Technical product information

Bentayga

Fuel tank internal fuel pump replacement - W12 TSI

Figure 1

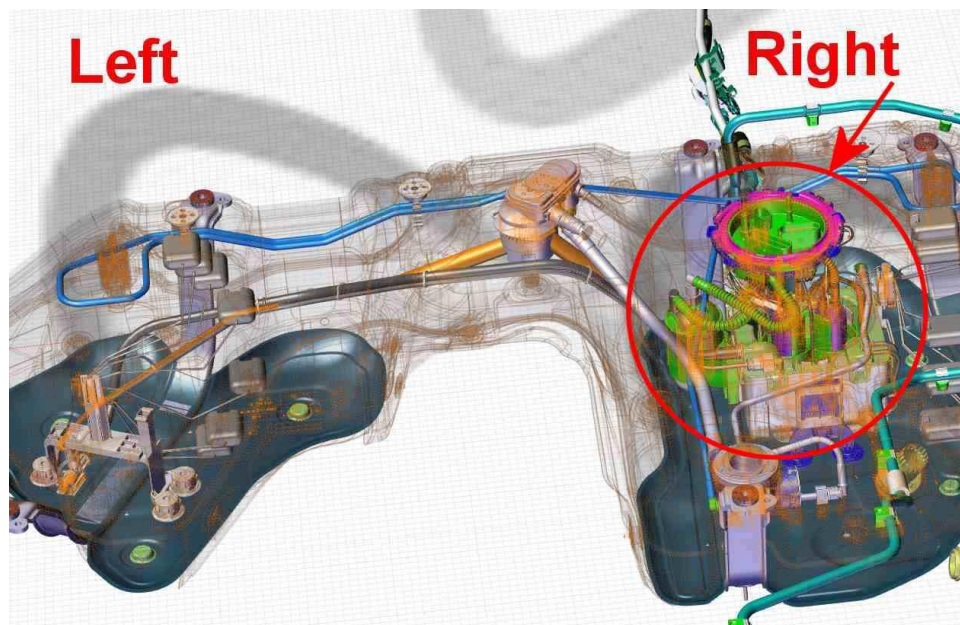
The twin fuel pumps which are part of the fuel delivery module (located on the right hand side of the fuel tank as Figure 1) have changed to an improved Diamond Like Coated (DLC) fuel pump

All W12 VIN's from SJA AF1ZV9KC027000 have DLC pumps fitted with the part numbers of 36A 919 087H or 36A 919 087J (depending on auxiliary heater specification) in conjunction with fuel pump control units 4M0 906 093K

The DLC pumps are compatible and can be fitted to vehicles up to VIN SJA AF1ZV9KC027000 HOWEVER you must ensure the correct specification fuel pump control units are fitted in conjunction with the DLC fuel pump assembly

Figure 2

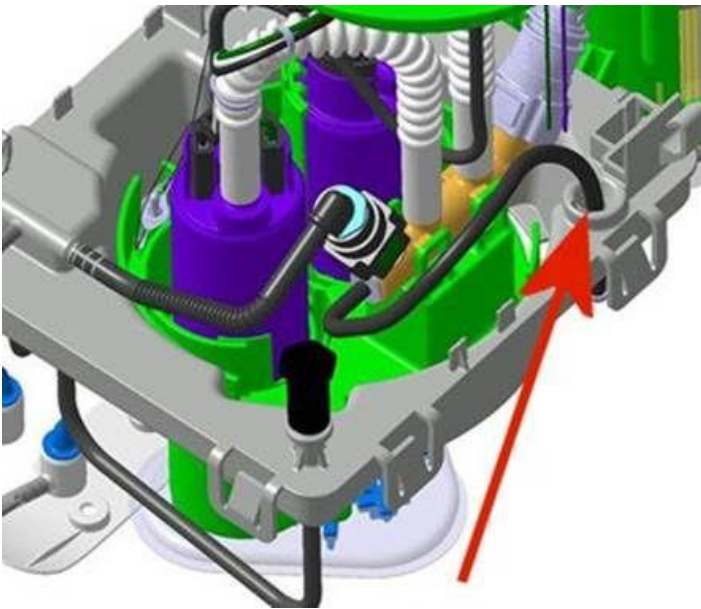
NOTE: Prior to ordering/replacing the fuel delivery module and/or control units, the retailer should refer to the vehicles Repair history to check/confirm the part numbers of any previously fitted fuel delivery module and control units, should the fuel pump assembly and control units have the following part numbers:

Fuel delivery module with bypass tube (Figure 2)

36A 919 087F - Fuel pump assembly without auxiliary heater

36A 919 087G – Fuel pump assembly with auxiliary heater Fuel

36A 906 093B – Master

36A 906 093C - Slave

All vehicles - Not fitted with a bypass tube

Standard fuel pump control units with the part number - 4M0 906 093K

MUST be fitted in conjunction with

DLC fuel pumps with the part numbers of 36A 919 087H without auxiliary heater

36A 919 087J with auxiliary heater

Should the vehicle require a fuel delivery module the DLC type pump assembly will be supplied 36A 919 087H or 36A 919 087J. Both fuel pump control units 4M0 906 093K should also be replaced to ensure correct configuration/compatibility

Should a fuel pump control unit require replacing the DLC fuel pump will also require replacement as control units with the part number 4M0 906 093K will only be available, In this scenario (due to potential mismatch) both control units should be replaced
